PRODUCT SUPPORT BULLETIN # 254 Revised

TOOL(S)\PRODUCT(S) AFFECTED:

6140 4-1/2" SANDER/GRINDER
SERIAL NUMBER RANGE 762-225408 thru 762-233406
6145 4-1/2" SANDER/GRINDER
SERIAL NUMBER RANGE 627-418057 thru 627-419390

SUBJECT: DEFECTIVE SPINDLE LOCK MECHANISM

14-30-0301 GEAR CASE ASSEMBLY

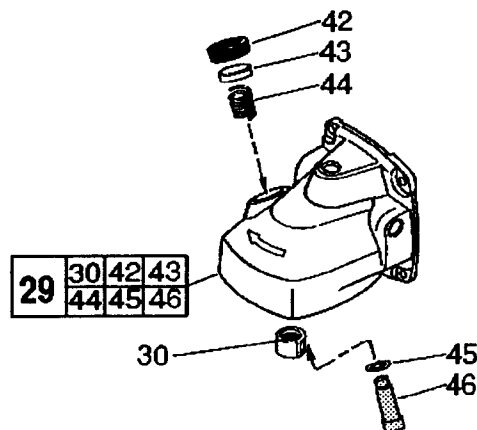
A POTENTIAL PROBLEM WITH THE GEAR CASE ASSEMBLY'S' SPINDLE LOCK MECHANISM NOT PROPERLY ENGAGING WITH THE SLOTS OF THE TOOL'S SPIRAL BEVEL GEAR (32-05-2230), EXISTS IN 6140 and 6145 4-1/2" SANDER/GRINDERS WITHIN SERIAL NUMBER RANGES LISTED ABOVE.

TO CORRECT THE PROBLEM THE GEAR CASE ASSEMBLY 14-30-0301 MUST BE CHANGED, AS THE COUNTER BORE FOR THE SPINDLE LOCK MECHANISM HAS BEEN REVISED.
